TVA-WBN-TS-07-14

**WATTS BAR NUCLEAR PLANT (WBN) - UNIT 1 - TECHNICAL SPECIFICATIONS CHANGE 07-14 - "APPLICATION TO REVISE TECHNICAL SPECIFICATIONS REGARDING CONTROL ROOM ENVELOPE HABITABILITY IN ACCORDANCE WITH TECHNICAL SPECIFICATION TASK FORCE (TSTF)-448, REVISION 3, USING THE CONSOLIDATED LINE ITEM IMPROVEMENT PROCESS"**

**WBN Technical Specification (TS) Change TS-07-14  
Inserts for Proposed Technical Specification Changes**

5.7 Procedures, Programs, and Manuals

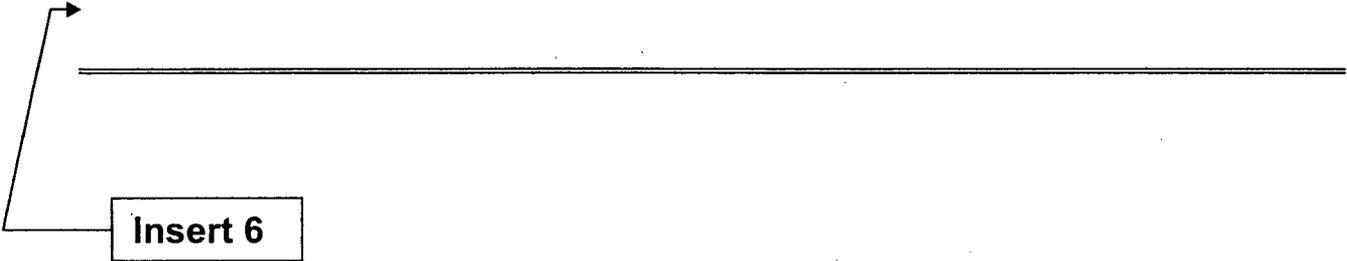
**Insert 6**

**5.2.7.20 Control Room Envelope Habitability Program**

**A Control Room Envelope (CRE) Habitability Program shall be established and implemented to ensure that CRE habitability is maintained such that, with an OPERABLE Control Room Emergency Ventilation System (CREVS), CRE occupants can control the reactor safely under normal conditions and maintain it in a safe condition following a radiological event, hazardous chemical release, or a smoke challenge. The program shall ensure that adequate radiation protection is provided to permit access and occupancy of the CRE under design basis accident (DBA) conditions without personnel receiving radiation exposures in excess of 5 rem whole body or its equivalent to any part of the body for the duration of the accident. The program shall include the following elements:**

- a. The definition of the CRE and the CRE boundary.**
- b. Requirements for maintaining the CRE boundary in its design condition including configuration control and preventive maintenance.**

- c. Requirements for (i) determining the unfiltered air inleakage past the CRE boundary into the CRE in accordance with the testing methods and at the Frequencies specified in Sections C.1 and C.2 of Regulatory Guide 1.197, "Demonstrating Control Room Envelope Integrity at Nuclear Power Reactors," Revision 0, May 2003, and (ii) assessing CRE habitability at the Frequencies specified in Sections C.1 and C.2 of Regulatory Guide 1.197, Revision 0.**

- d. Measurement, at designated locations, of the CRE pressure relative to all external areas adjacent to the CRE boundary during the pressurization mode of operation by one train of the CREVS, operating at the flow rate defined in the Ventilation Filter Testing Program (VFTP), at a Frequency of 18 months on a STAGGERED TEST BASIS. The results shall be trended and used as part of the 18 month assessment of the CRE boundary.**

- e. The quantitative limits on unfiltered air inleakage into the CRE. These limits shall be stated in a manner to allow direct comparison to the unfiltered air inleakage measured by the testing described in paragraph c. The unfiltered air inleakage limit for radiological challenges is the inleakage flow rate assumed in the licensing basis analyses of DBA consequences. Unfiltered air inleakage limits for hazardous chemicals must ensure that exposure of CRE occupants to these hazards will be within the assumptions in the licensing basis.**

- f. The provisions of SR 3.0.2 are applicable to the frequencies for assessing CRE habitability, determining CRE unfiltered inleakage, and measuring CRE pressure and assessing the CRE boundary as required by paragraphs c and d, respectively.**
